CS Memorandum No. 1409

Subject: Configuration Management Board Meeting No. 119

CMB Meeting Minutes #119

DATE: March 28, 2013
 MEETING DATE: **March 27, 2013**
 LOCATION: 821 Howard St, Main Conference Room
 TIME: 3:00 PM
 ATTENDEES: A. Hoe (AH), R Edwards (RE), M. Benson (MB), R. Redmond, (RR), R. Nguyen (RN), B. Kelleher(BK), E. Stassevitch (ES), B. Ward (BW), B. Lebovitz (BL), L. Zurinaga (LZ)
 COPIES TO: Attendees: S. Farhangi (SF), J Funghi (JF), A. Wong (AW), J. Park (JP), S. Wilson (SW), M. Latch (ML), J. Wang (JW), A. Read (AR), D. Kuehn (DK)
 REFERENCE: Project No. M544.1, Contract No. 149 Task 1-8.02
 Final Design
 SUBJECT: Configuration Management Board Meeting # 119 – Rev. No. 0

CENTRAL SUBWAY TUNNEL CONTRACT
SFMTA CONTRACT MR 1252
TRAFFIC CONTROL PLAN

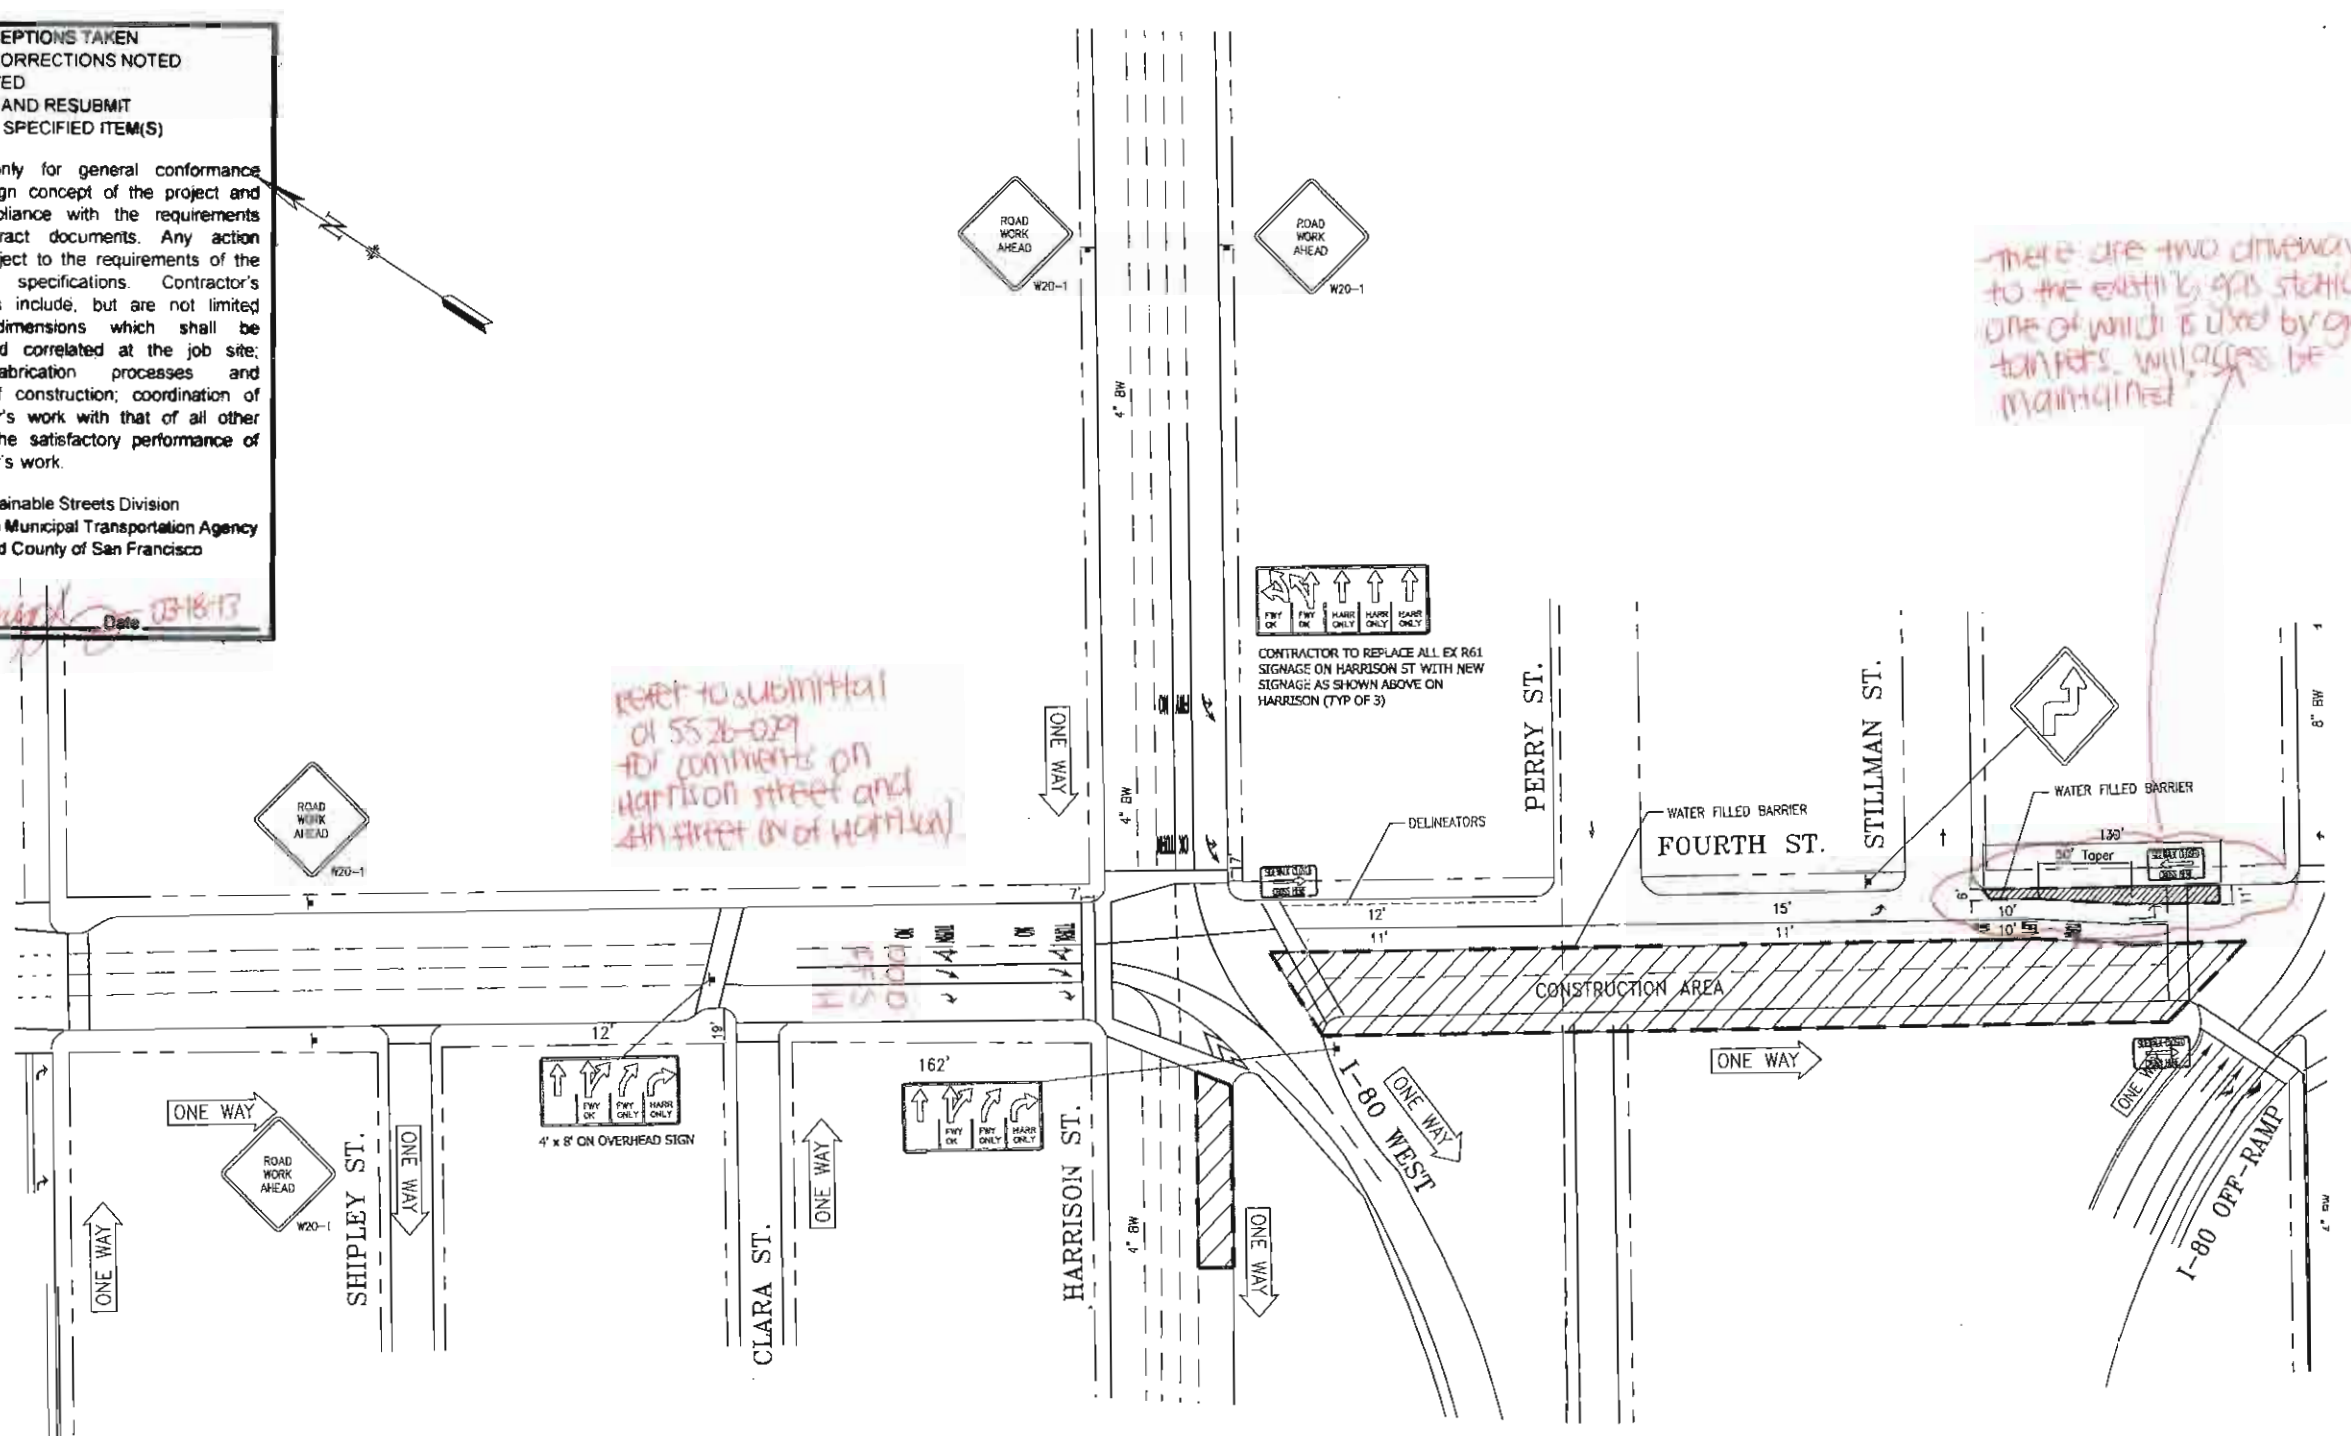
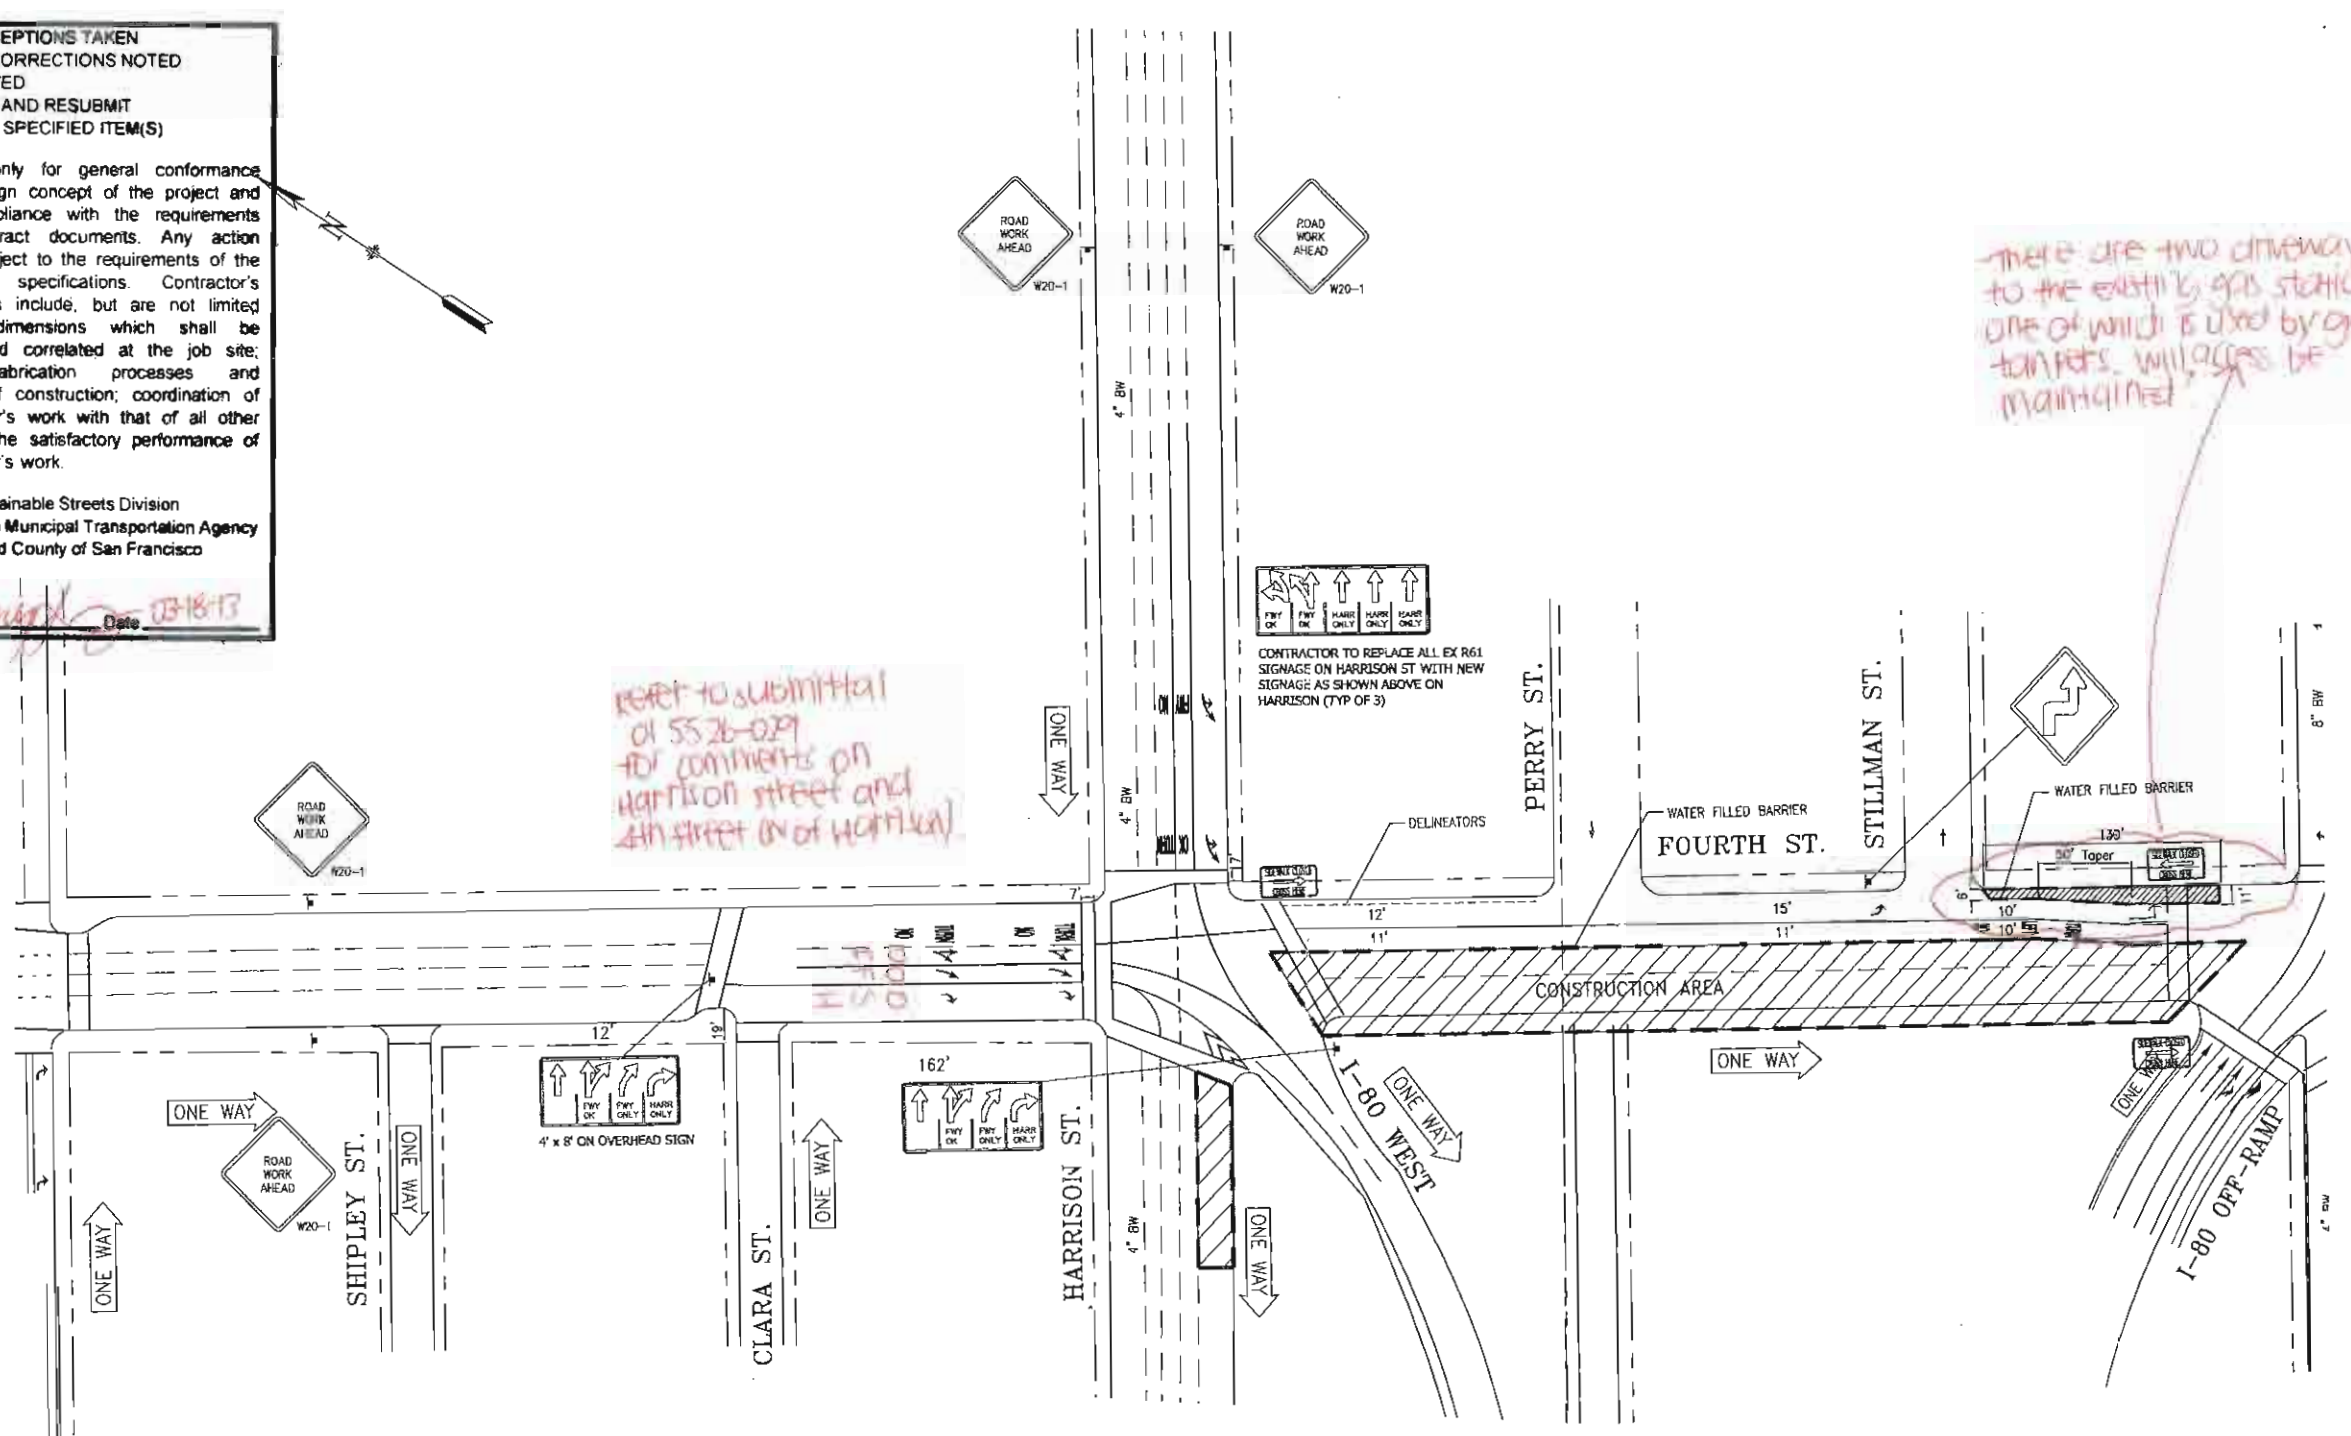
ITEM #	DISCUSSION	ACTION BY DUE DATE
2-	<p>1252 - Segment Spalls Repair Procedure Submittal – R. Redmond presented for review the Contractor’s proposed procedure for repairing the non-structural damage to the segments which include minor spalling or chips in the concrete. The submittal proposes a fast setting patching material to be used “Crete Red Line” (see attached). Review of the submittal by the CMB suggested the submittal response be Revise and Resubmit with the following bullet points be addressed with resubmittal:</p> <ul style="list-style-type: none"> • Designer of Record comments are to returned procedure, as noted, but revise and resubmit before repair can be performed <ul style="list-style-type: none"> ○ In particular, how deep , how wide , does any weld crete get applied ○ To what extent is the spall to large or too deep for this application ○ Does the spall need to be chipped back to more sound concrete ○ How • Photo 3 - not to be considered here, as this spall is " into " the zone of the gasket • Identify Luis Piek (a PE ??) , <ul style="list-style-type: none"> ○ Is he the Quality reviewer?? ○ who is the reviewer and acceptor of the actual repair made (Luis ??) or the (Segment Manufacturer)
